ADDENDUM NUMBER 1

DATE: 11/14/2024

PROJECT: Clinton Twp. Fire Station Renovations

PROJECT NUMBER: 0242-0451

4 INTER. ELEV. D @ SHOWER RM.
A412 1/2" = 1'-0"

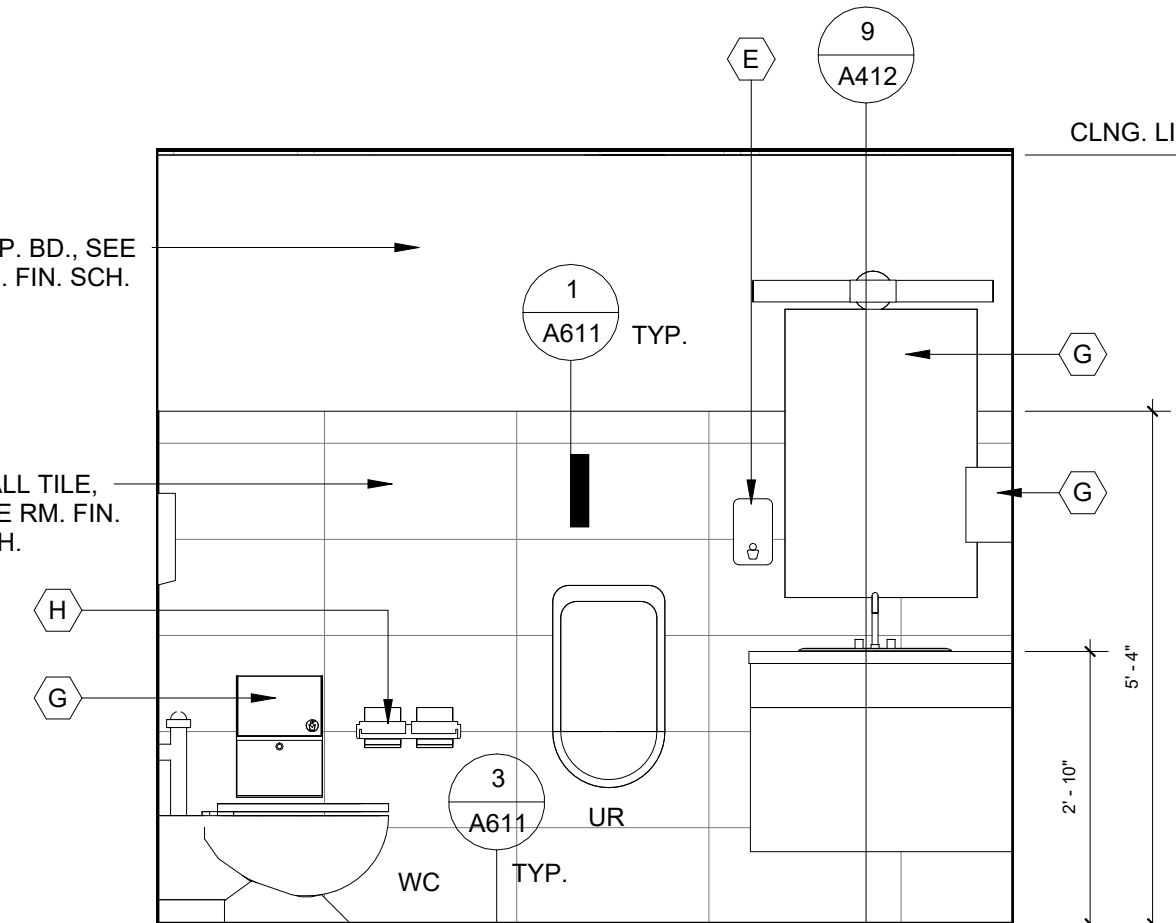
10. Q: Per page A412, please clarify the floor tile type to be used regarding the 12x24 sizing.
A: For the area within the showers use 2"x2" mosaic version of the same tile.

1. SHEET A032: (reissued)
 - a. Revised Mechanical/Plumbing specifications.
2. SHEET A412: (reissued)
 - a. Revised lavatory dimensions.

1 FIRST FLOOR PLAN- HVAC FLOOR PLAN
M101 1/2" = 1'-0"

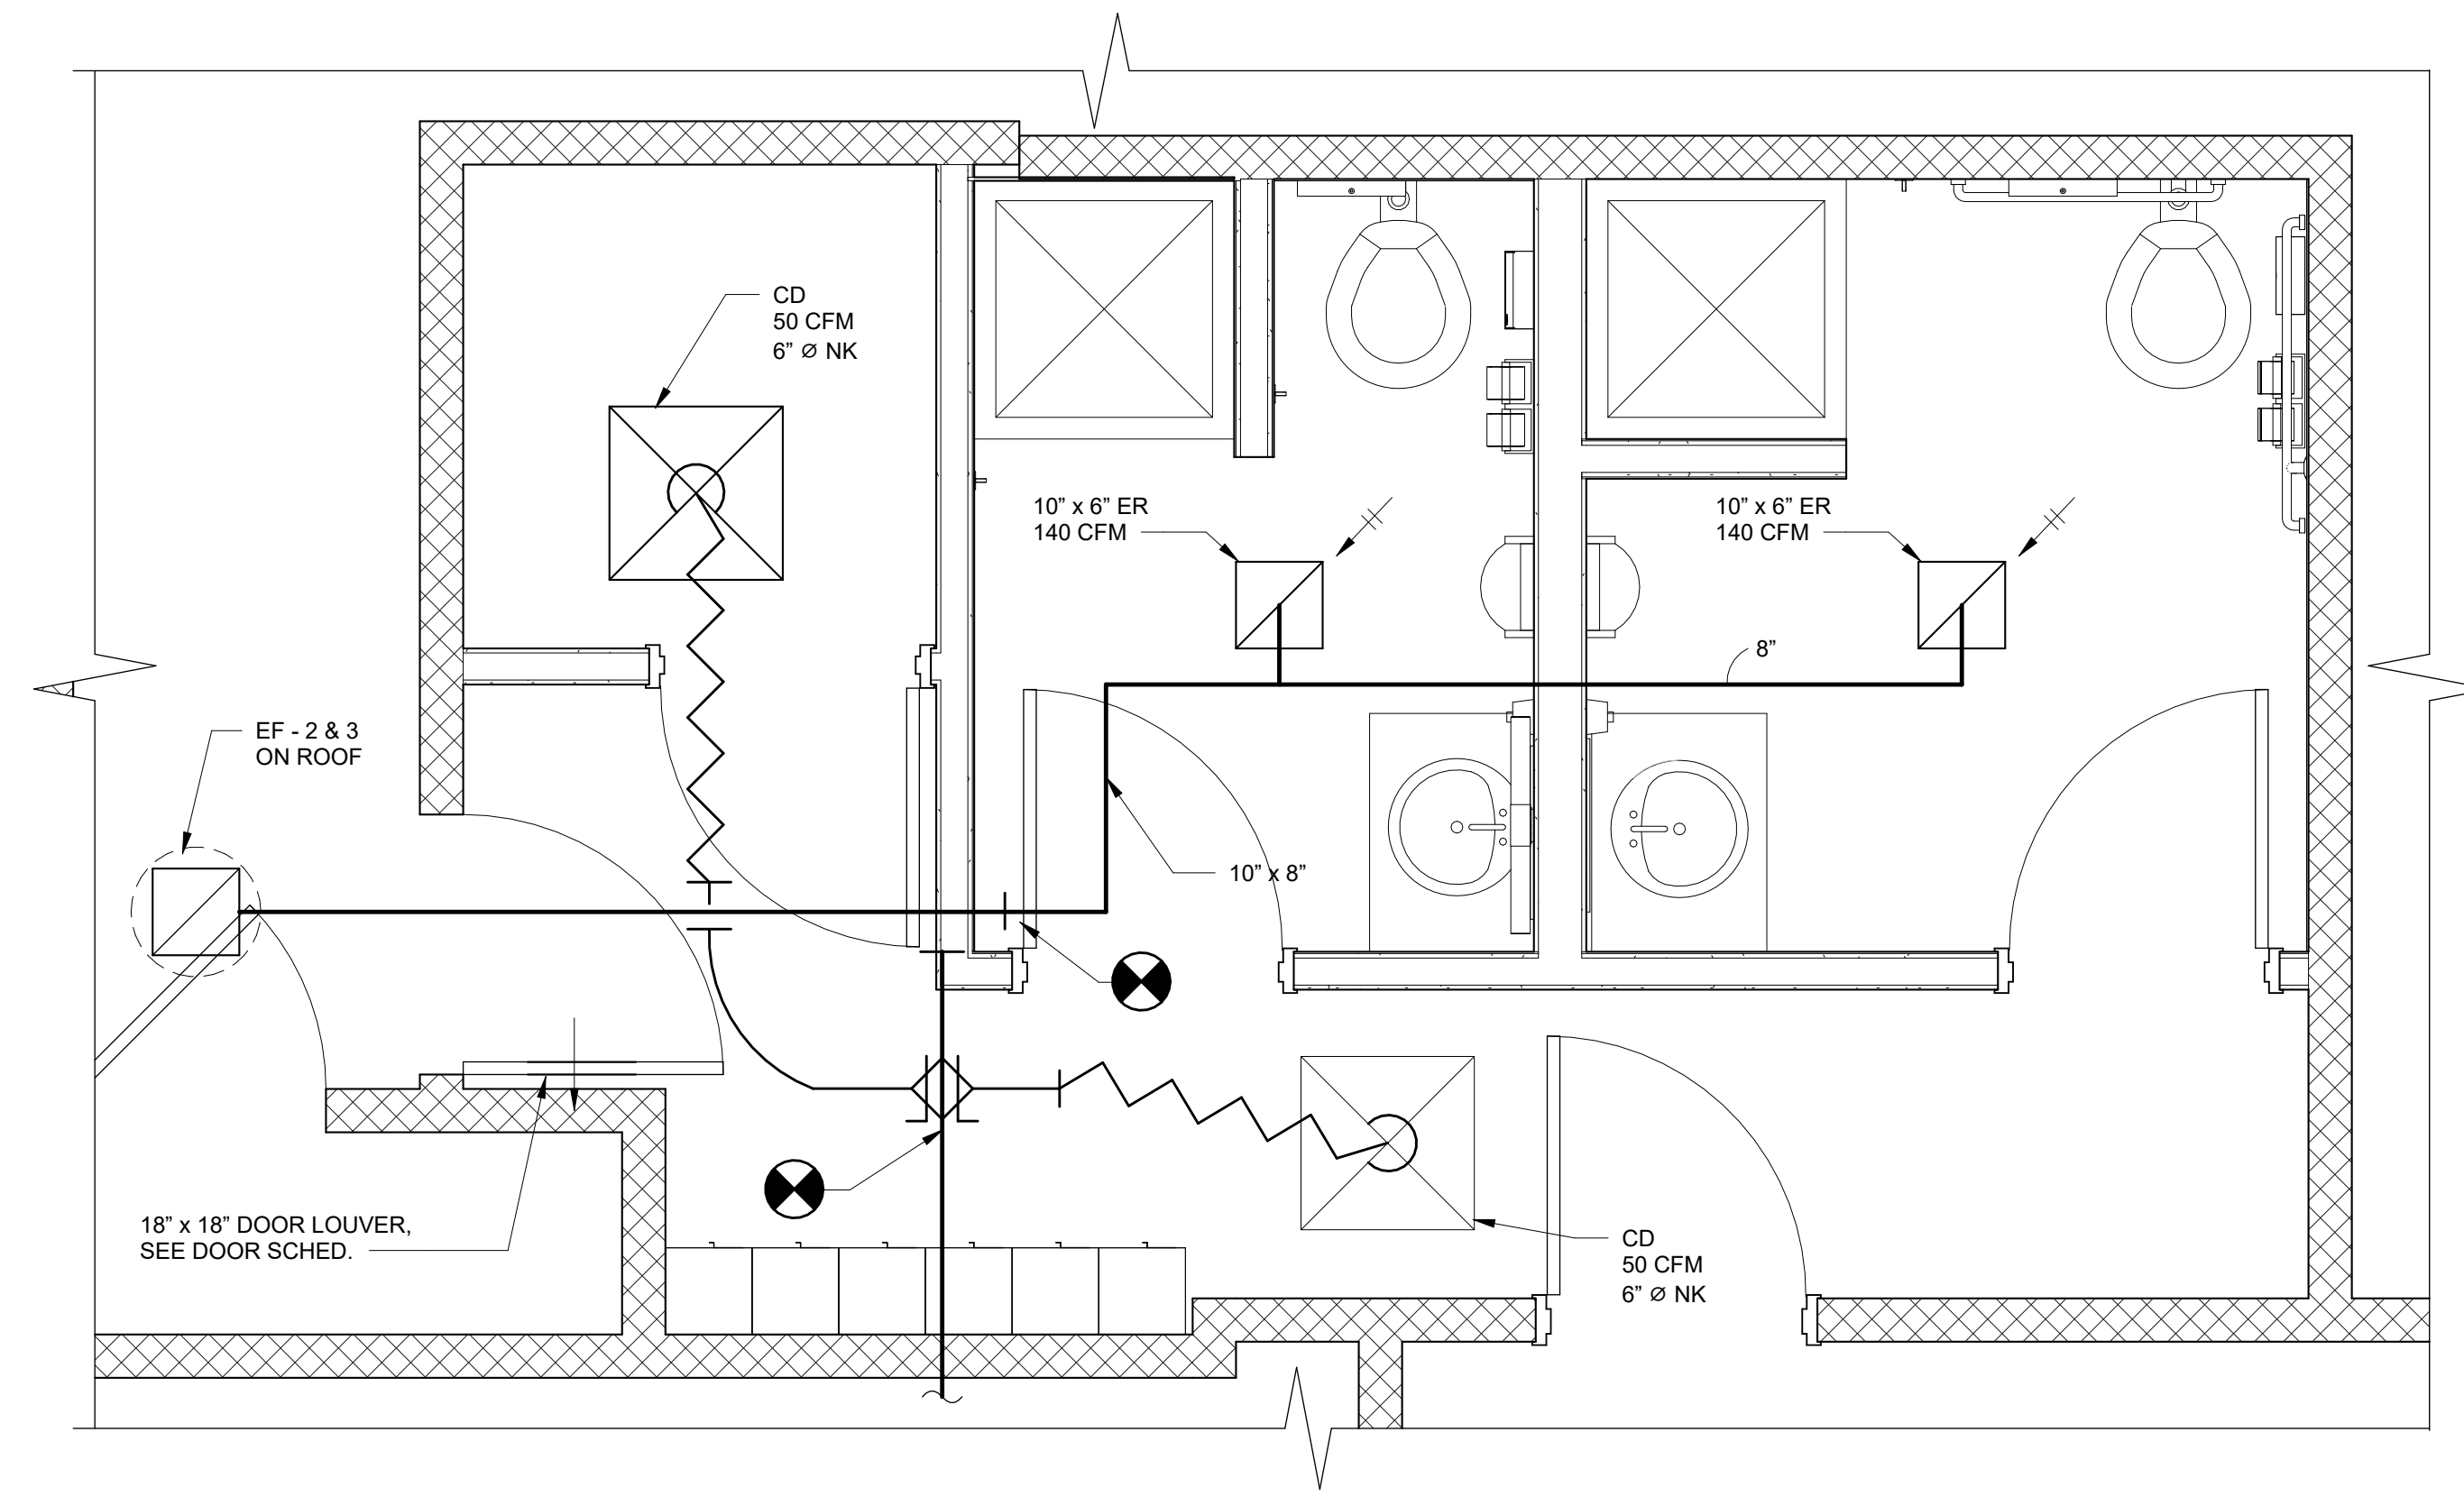
3. Q: Per page A032, please clarify notes 9 & 10 in more detail.
A: See revised sheet M101 for updated equipment schedules.
4. Q: Per page M101 please clarify exhaust fan specifications.
A: See revised sheet M101 for updated exhaust fan specifications.

1. SHEET M101: (issued/reissued)
 - a. Added specifications for equipment.
